Golden Crescent Workforce Solutions Lease Space RFP Questions

General Questions - Responses

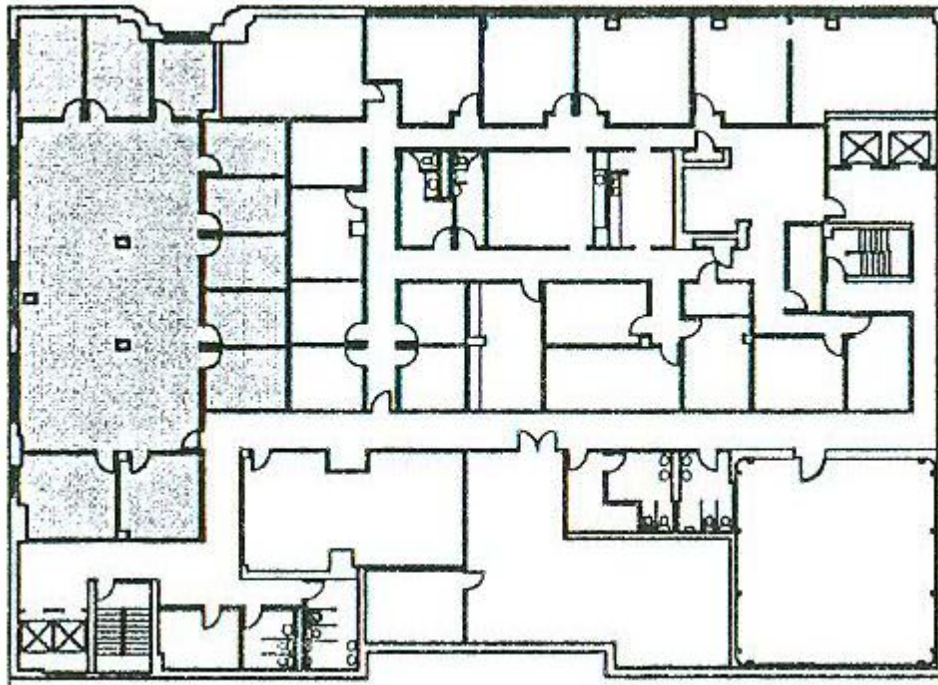
6. Request to see current Texas Workforce floorplans and configuration. **Yes. The attachment shows general leased space for 2nd and 5th floors.**
7. Renovations to be amortized and included in the lease. How is lessor to know extent of renovations needed prior to submitting RFP response?
We suggest you visit our Victoria location to get some insight as to what is needed and how the current layout is structured. There could be as many as five different groups in an open space (Bullpen)
